SI B52 04 19
Seats

SECOND ROW 60/40 DRIVERS SIDE SEAT INTERMITTENTLY WON'T LATCH

| G05 (X5 Sports Activity Vehicle) | G07 (X7 SAV) | | |

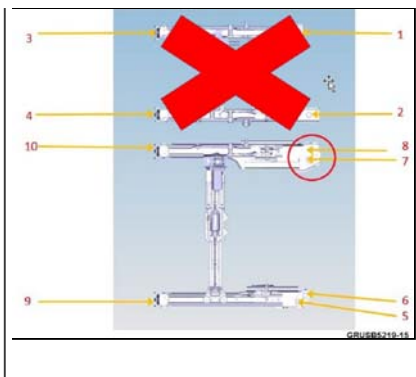
As of March 2019 production, two machined washers (shown) were added to the bottom of the inner seat rail on the driver's side (left rear) of the 60/40 split 2nd row seat.

For vehicles with this specific complaint that were produced prior to March 2019, a comparable correction is to add two 2mm thick flat washers in this location.

6. Install 2 flat 2 mm thick washers under rear of inner rail of the 60% structure.

Washers are installed between the floor of vehicle and the rear of the inner seat rail.

The washers must have-

- 15mm inner diameter hole for the bolt fitment
- Outside diameter must be at least 30mm
